Product Change Notification

PCN-028_2023_0-OMTO2304801

EMC Robustness Improvement, RDL enlargement

GO-SMS series

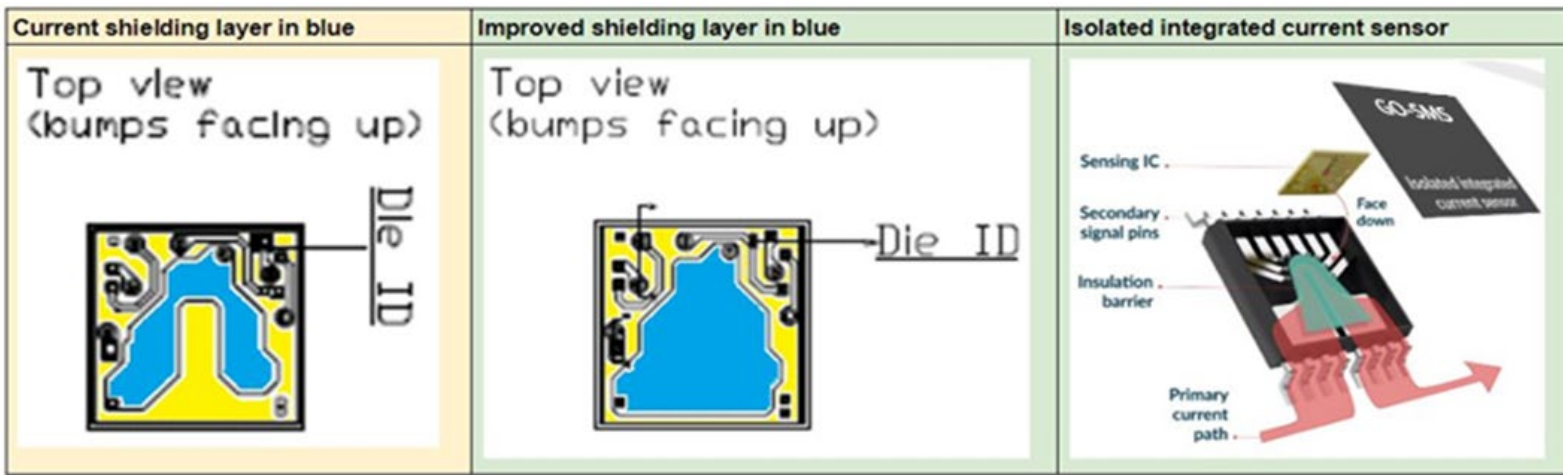
EMC Robustness Improvement.

Limited enlargement of the shielding layer (called RDL) inside the package, refer to following image.

No change on the CMOS design.

This shielding layer enlargement leads to more robust EMC performance as semiconductor circuitry is better shielded from transients on the primary current path.

In currently produced GO-SMS models, RDL is not covering the OCD_int circuitry.

This may cause susceptibility of OCD_int to high voltage variations dv/dt .

It has been observed that for large dv/dt , the OCD_int might trigger even without any applied current.

Decision was taken to enlarge RDL, protecting OCD_int from capacitive coupling and therefore avoid false triggering.
